Office Action Summary

10/039,573

This is the second Office Action for serial number 10/039,573, Tool Hanger, filed on January 7, 2002. Claims 1-3, 8, 9, and 14 are pending.

223,082

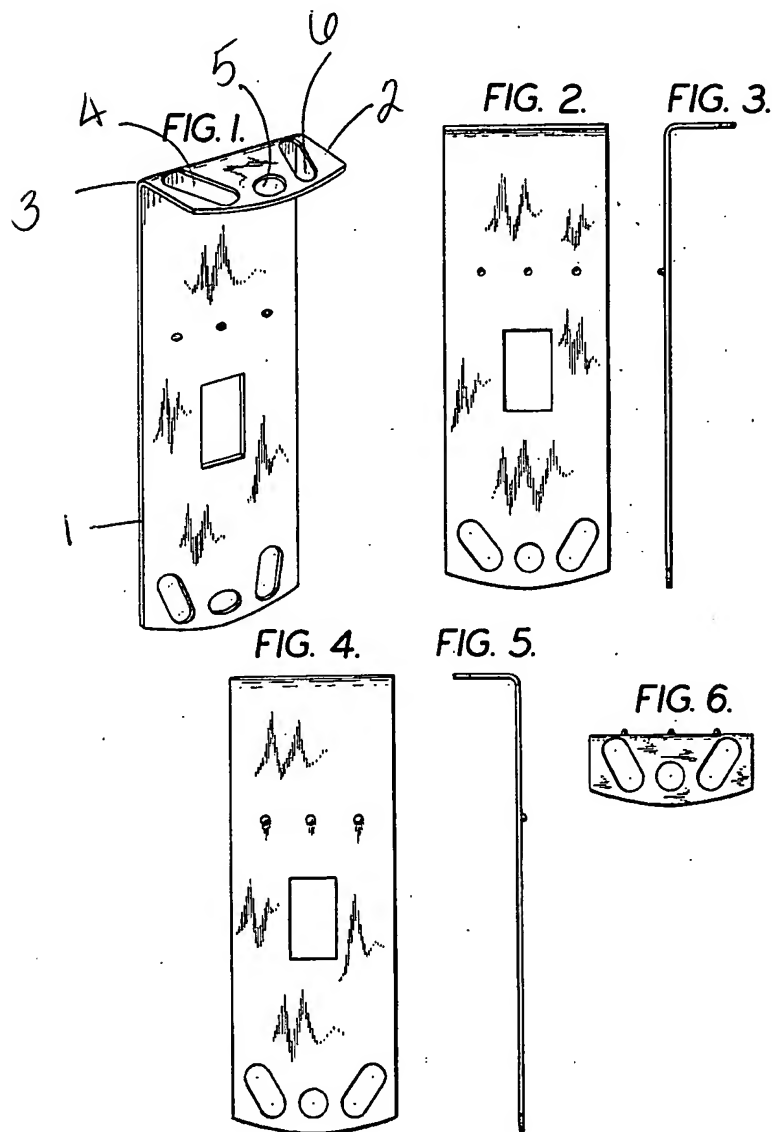
Claims 1, 2, 8, 9 and 14 are rejected under 35 U.S.C. 102(b) as being anticipated by U.S. Patent D223,082 to Fromm. Regarding claims 1, 2, 8, 9 and 14, Fromm

discloses a hanger (see attached marked copy of Fig. 1) comprising: a horizontally oriented portion (1); a vertically oriented portion (2) joined to the horizontally oriented portion (1) at first ends thereof at a bend (3); and two or more non-axially aligned apertures (4-6) located at a second end of the horizontally oriented portion (1), wherein two apertures are non-circular (4, 6) and wherein one aperture (5) is located in the center of the second end, and wherein the apertures are dimensioned and spaced to permit secure connection to an object in two or more locations.

Claim 3 is rejected under 35 U.S.C. 103(a) as being unpatentable over Fromm. With regards to claim 3, Fromm discloses the hanger as applied above, but does not disclose any of the apertures (4-6) being threaded. However, it would have been obvious to one of ordinary skill in the art at the time the invention was made to have modified the aperture (5) to be threaded because one would have been motivated to provide a means for securing alternative fasteners, such as screws or bolts, to the bracket since nails, screws, and bolts are well known for their use in the fastening art and the selection of any of these known equivalents and their complementary aperture to attach the bracket to an object would be within the level of ordinary skill in the art.
